SERVICE BULLETIN

SUBJECT: Recommended Replacement of AEL12892 Thrust Buttons

PURPOSE: To notify customers of a potential incorrect material

DOC NO REVISION
E-SB007

Figure 1.

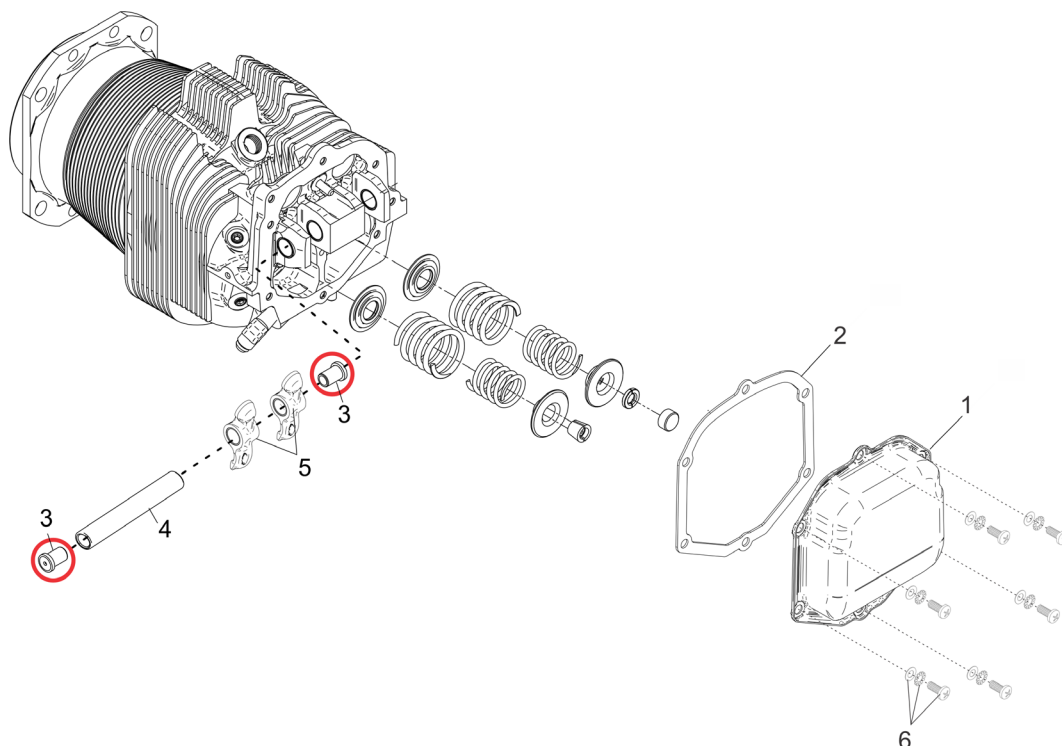
1. Disconnect power to engine.
2. Make sure engine is cool.
3. Remove the rocker cover (Figure 1) (1) and gasket (2) from the cylinder assembly. Discard the gasket (2).

If signs of overheating or accelerated wear of the thrust button (3) are found, ensure that no debris is present in the cylinder drain back line, oil sump, or in the rocker box area and contact Continental. If none are found, proceed to step 4

4. Remove the thrust buttons (3). Removal of the shaft (4) and rockers (5) is not required.
5. Replace both thrust buttons (3) regardless of condition.
6. Install the rocker cover (1) with a new gasket (2) on the cylinder assembly.
7. Install and torque hardware (6) to the value specified in the engine's primary Instructions for Continued Airworthiness (ICA).
8. Enable power to the engine.
9. Complete the "Operational Ground Check" per the engine's primary ICA.
10. Make an appropriate entry in the engine logbook.

Figure 2.

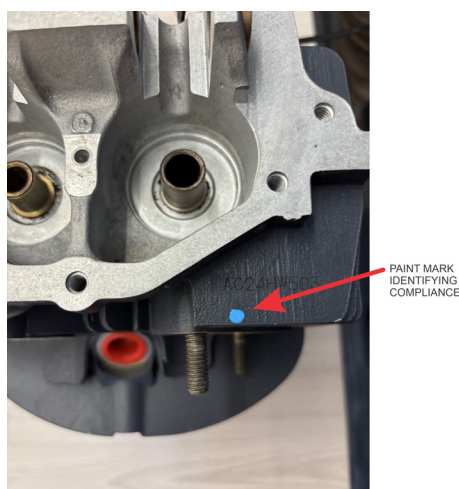
Continental has verified the material on some cylinders at our distributor's facility. The paint mark shown in Figure 2 identifies compliance. If this mark is on the cylinder, no further action is required.
